Addendum No. 3  
Regional Carrizo Project - Schertz Parkway Pump Station  
SAWS Job No. 10-8617  
SAWS Solicitation No. B-11-061-RA

### ADDENDUM NO. 3

March 26, 2012

1. The purpose of this addendum is to issue revisions to the plans and specifications for the Regional Carrizo Project - Schertz Parkway Pump Station (SAWS Job No. 10-8617; SAWS Solicitation No. B-11-061-RA). All questions received by the March 21, 2012 deadline are addressed in this addendum.

**8 HMAC PAVEMENT SECTION**  
 SCALE: N.T.S.

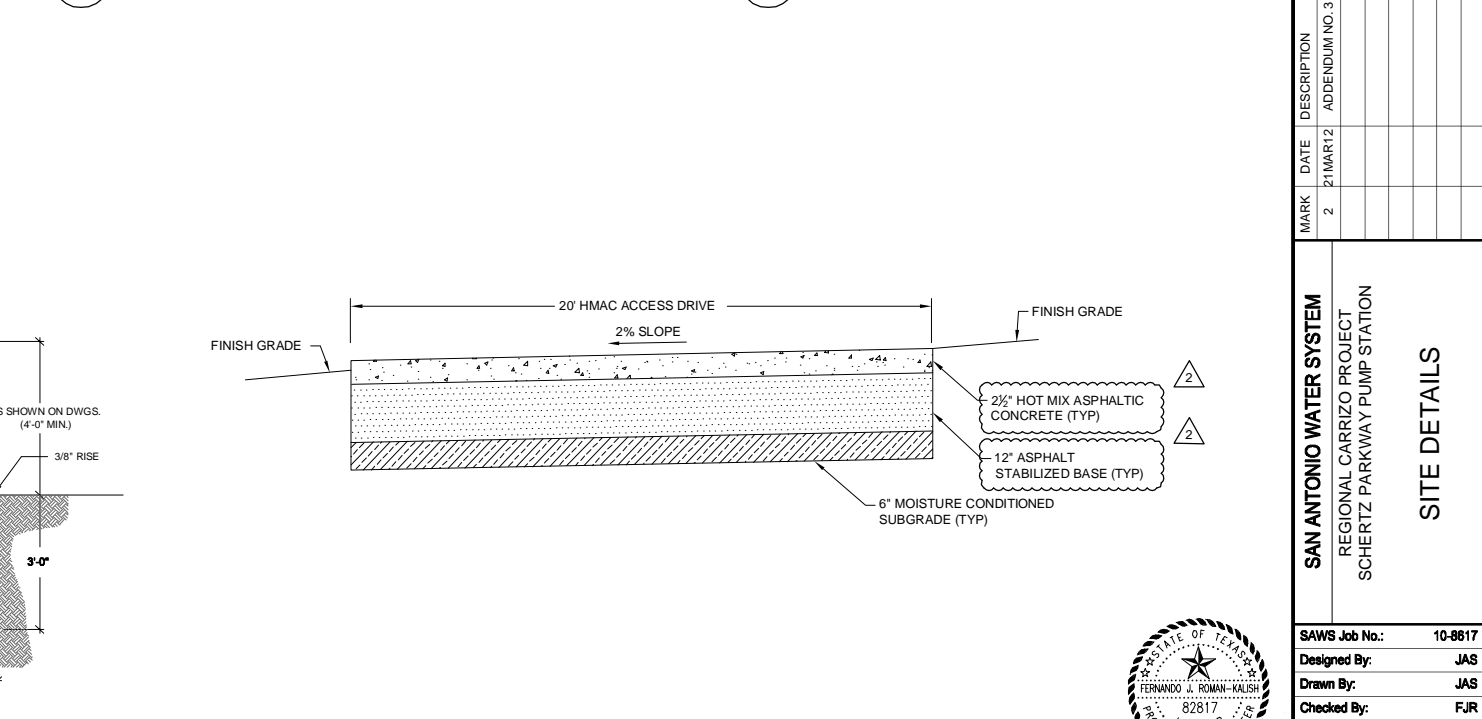
Sheet C-500 plan detail 8 –HMAC pavm't section shows 6" HMAC over 12" Flexible base for the Access Roadway. The specifications for Asphaltic Concrete Pavement; Section 02513 , Calls out for 6" HMAC over 12" of Asphalt Treated Base. Could you please clarify which is correct?

*Response: Asphalt stabilized base is required in accordance with Section 02513. Changes to Sheet C-500 (19 of 130) are indicated with revision clouds in the revised drawing included with Addendum No. 3.*

1. Sheet C-500 (19 of 130): Changes to the HMAC Pavement Section are indicated with revision clouds in the revised drawing included with Addendum No. 3.

SECTION CONCRETE APRON THRU BAFFLES

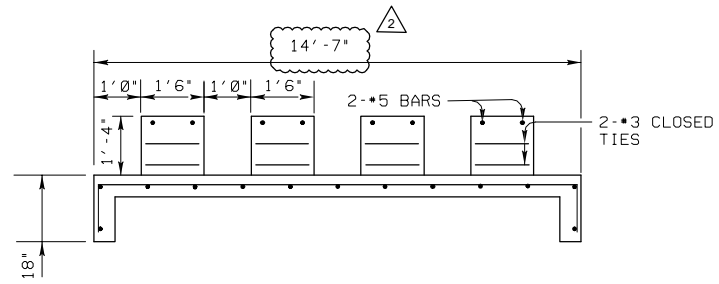
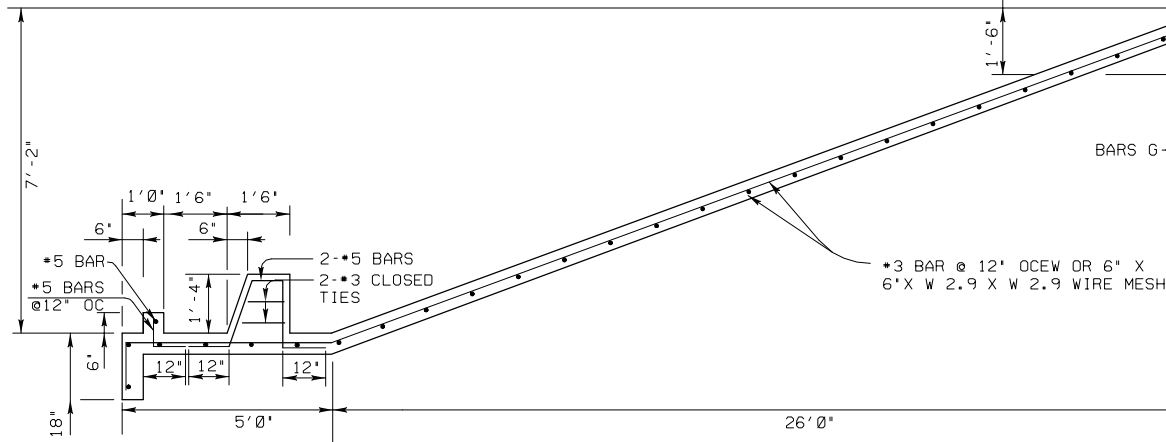
On Sheet C-501 "Section Concrete Apron Thru Baffles" calls out an 11' width. However, the width from the Table of Variable Dimensions requires 3' 7" be added to the "W" which is 11'. Should the width of the slope paving be 14'7"?

*Response: Yes, reference revisions to Sheet C-501 (20 of 130) included with this addendum.*

2. Sheet C-501 (20 of 130): Changes to the concrete apron are indicated with revision clouds in the revised drawing included with Addendum No. 3.
3. Sheet M-120 (30 of 130): Revise the Sheet as follows:

**S-103**  
 Sheet 39 of 130

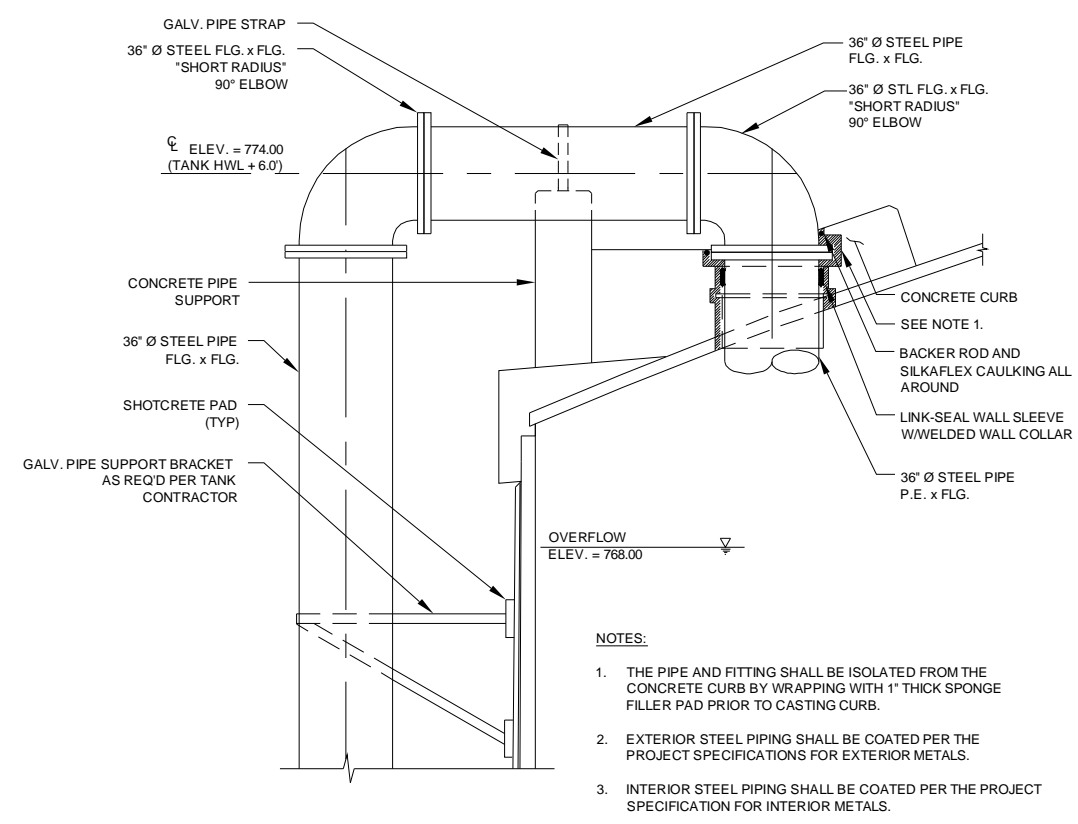
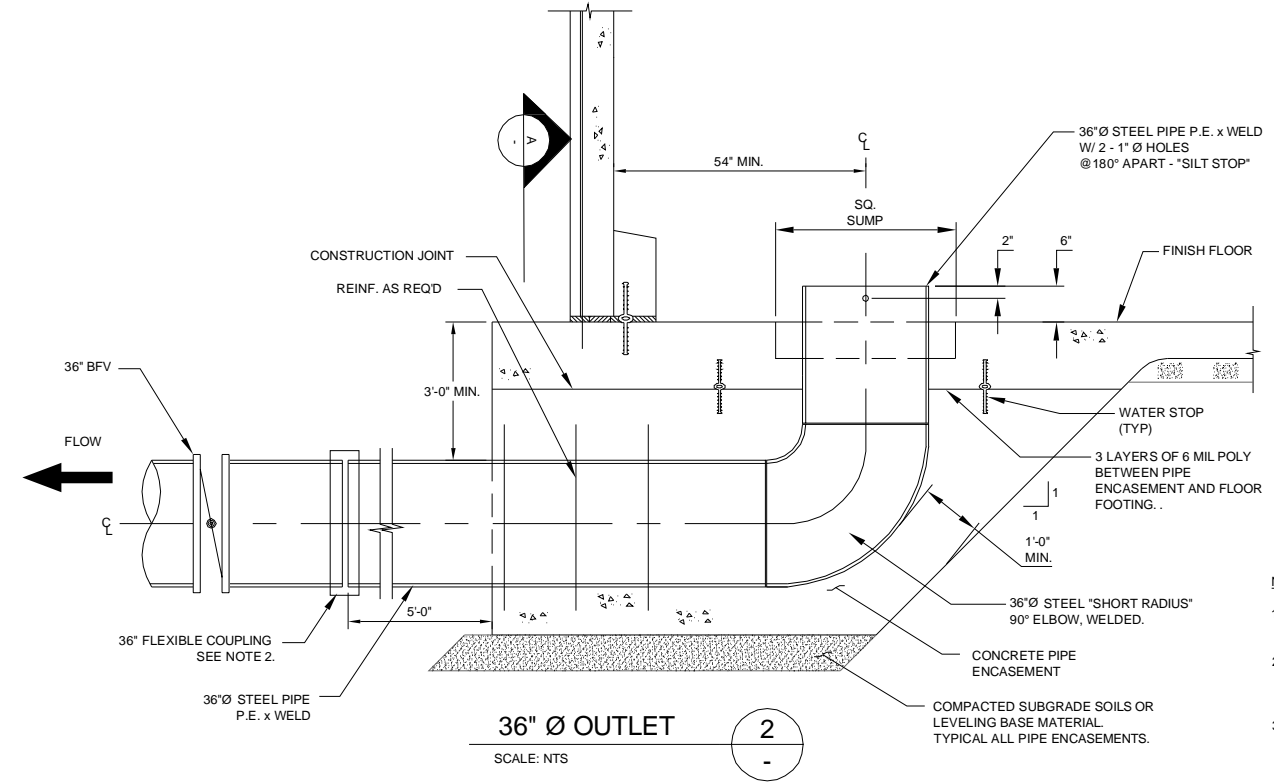
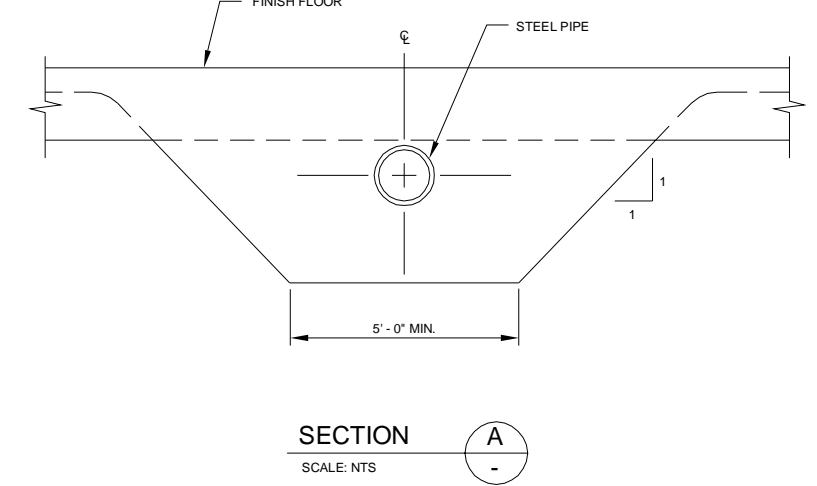
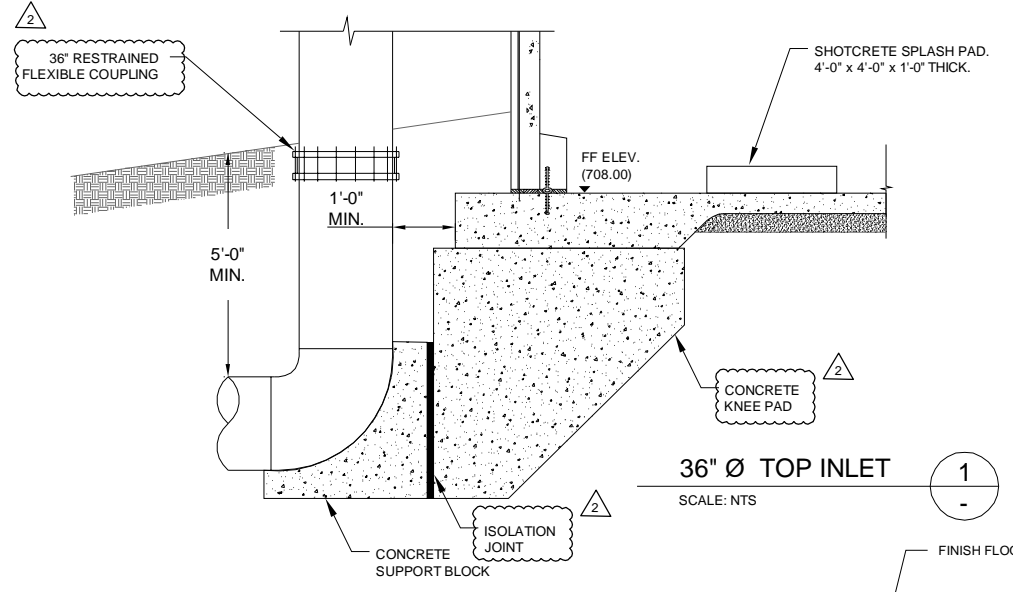
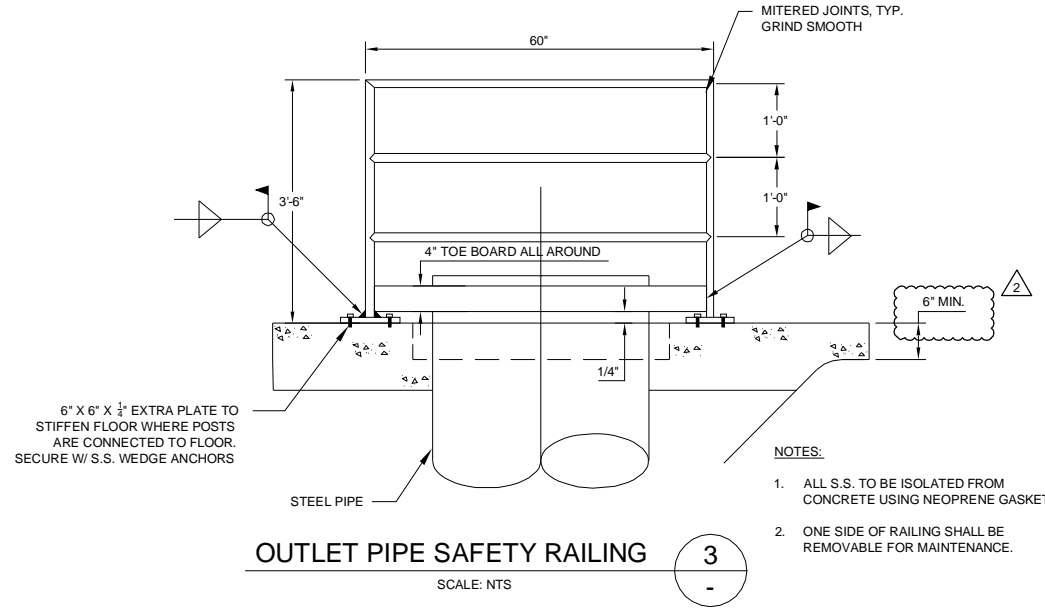
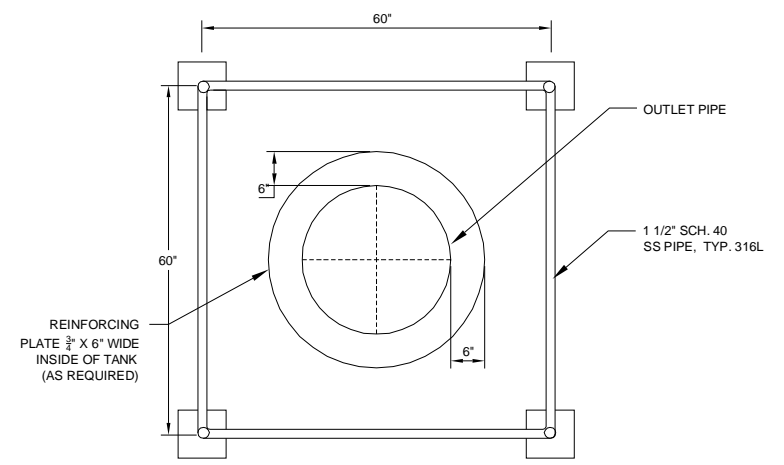
1. Sheet S-103 detail 3 indicates a minimum 4” thick floor, however, all other references to the minimum tank floor thickness indicate a minimum 6” floor is required on the ground storage tank. Please confirm the minimum thickness is 6”.  
*Response: The minimum thickness for the tank floor shall be 6”. Changes are indicated with revision clouds in the revised drawing included with Addendum No. 3.*

2. Sheet S-103 detail 1, based on the depth of the inlet pipe as it approaches the tank there is a concern of undermining the tank foundation when the 36” inlet is installed below grade. We would recommend that a concrete knee pad be required beneath the tank foundation at this location similar to that shown on Sheet S-104, section B. The inclusion of this knee wall will minimize the concerns for undermining the tank foundation. Please confirm this will be required by all bidders on this project.  
*Response: A concrete knee pad shall be included. Changes are indicated with revision clouds in the revised drawing included with Addendum No. 3.*

3. Sheet S-103, Detail 1 – Please confirm that a flexible coupling is required and should be added to the vertical riser portion of the 36-inch inlet line to accommodate the anticipated wall movement and tank settlement.  
*Response: A flexible coupling shall be included. Changes are indicated with revision clouds in the revised drawing included with Addendum No. 3.*

6. Sheet S-103 (39 of 130): Changes to Detail 1. 36" Ø Top Inlet and Detail 3. Outlet Pipe Safety Railing are indicated with revision clouds in the revised drawing included with Addendum No. 3.
